Thornton Accessibility Action Plan April 2023

4.1 - ACTION TABLE

Diagram 3 Relationship of ramp gradient to the going of a flight

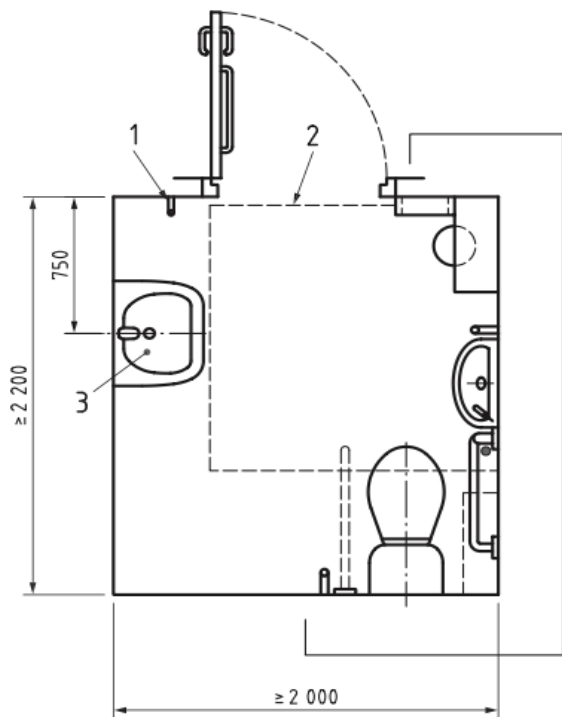
Item Ref.	Details / Issue	Recommendation	Est Cost	Action Taken
PRIORITY A				
3.1	<p>Thornton School is located on a sloping site; various ramps were identified throughout the school.</p> <p>The ramps located at the main entrance, the rear sixth form entrance, and towards the gates that separate the school from the leisure centre, were suitably graded.</p> <p>The ramp leading towards the sports fields, near to the main pedestrian gate, was steep and uneven, which may not be suitable for a wheelchair user.</p> <p>The ramp to the front of the canteen was slightly steep and may not be suitable for all wheelchair users.</p>	<p>The external ramps identified should be subject to remedial works to reduce the gradient to a reasonable slope that can comply with BS8300 and ADM-2:1.26 requirements.</p> <p>Any permanent ramp must be a maximum 1:12 over a maximum going of 2m, it should be a minimum 1.2m wide and feature 1.2m landings at head and foot, handrails to both sides and a contrasted sloped surface.</p>	M

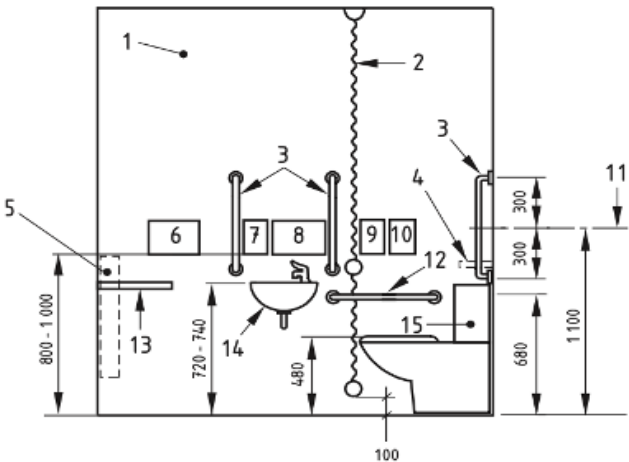
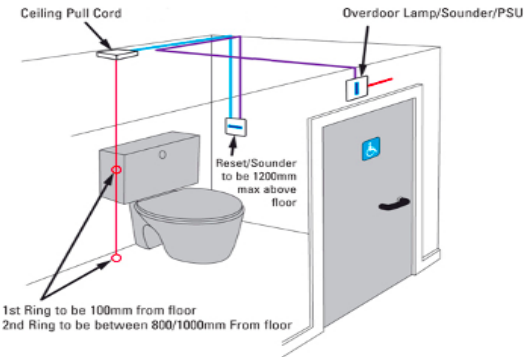
13.2	<p>Facilities were provided to the newer building of the school, on H and F Floors, as well as in Horizon.</p> <p>Further facilities were not provided to C Floor, where level access could be gained, or A Floor. This building required stepped access. Refer to section 7.3.</p> <p>The accessible facility is on the first floor in the leisure centre. No accessible facility is available on the ground floor.</p>	<p>Should level access to the old building be provided, an architectural feasibility study should be undertaken to provide a BS8300 compliant accessible WC facility within this area. A potential area location for this could be within the WC facility next to the quiet room.</p> <p>BS8300, Figure 41, should be referred to for the suggested layout and guidance.</p> <p>An alarm should be installed within the facility and the fittings should be well contrasted.</p>	M/ST

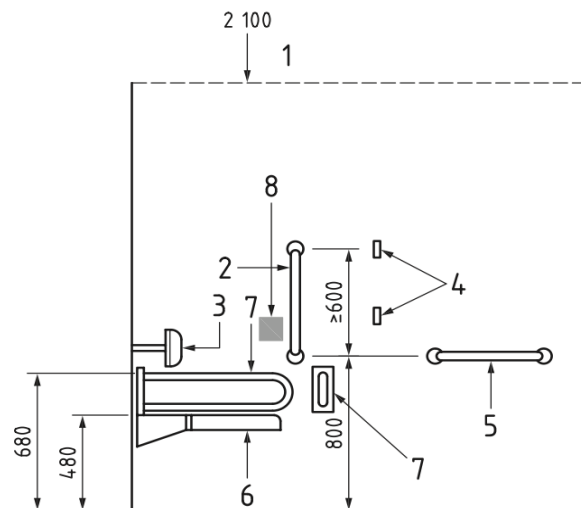
9.1	<p>Two internal ramps were identified, between the lift and the Common Room on the bottom floor of the New Building, as well as by B21.</p> <p>Short steep ramps are provided to enter the Studio Hall which have no contrasting to their surfaces. Without the forewarning, the gradient could take someone by surprise and cause a potential stumbling hazard.</p>	<p>Ideally, the ramps should be subject to remedial works to reduce the gradient to a reasonable slope that can comply with BS8300 and ADM-2:1.26 requirements.</p> <p>In the short term, colour contrast should be added to the surface of the ramps.</p> <p>☐</p> <p>According to BS8300 - The surface of a ramp should contrast visually with the landings and the edge protection so that its presence is discernible by people who are blind or partially sighted.</p>	M

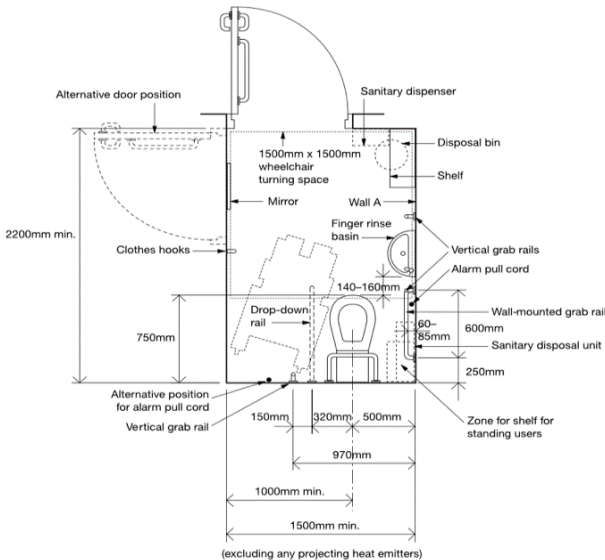
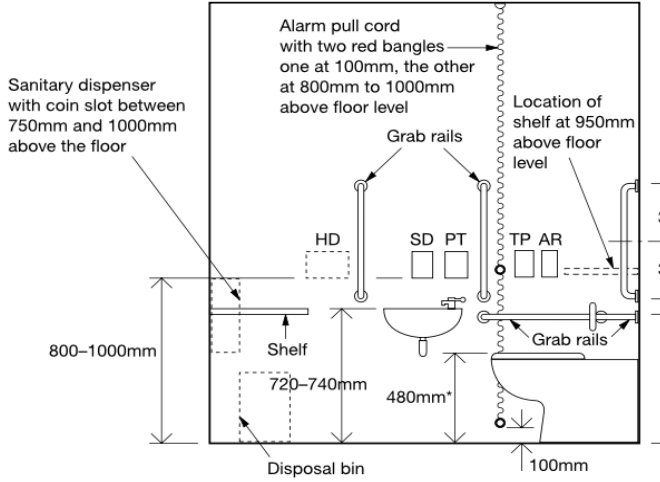
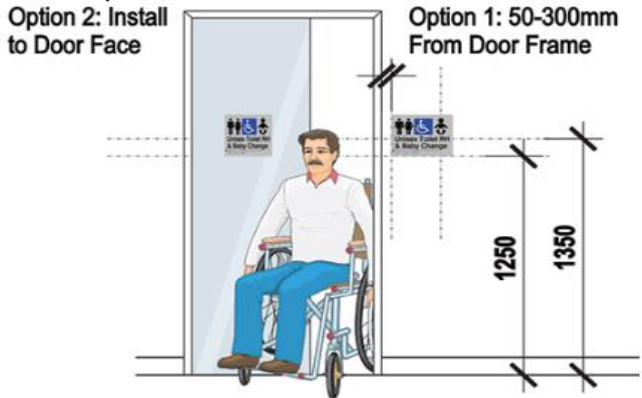
The facility opposite H9, measured to be approximately 1470mm by 2024mm. This facility was narrowed further to approximately 1550mm structurally, narrowing the transfer zone.

The facility on F Floor was measured to be approximately 1695mm by 1550mm.

The facility in Horizons was measured to be approximately 2265mm by 1510mm.

The facility on H Floor and F Floor may not be suitably sized for wheelchair users.

An Accessible WC and changing area with hoist was available on first floor/ gym floor. Compartment dimensions 3020mm by 3470mm.

During future developments, the architectural feasibility of increasing the size of the accessible WCs on H and F Floor should be taken into consideration.

Refer to ADM diagrams 18 and 19 for guidance.
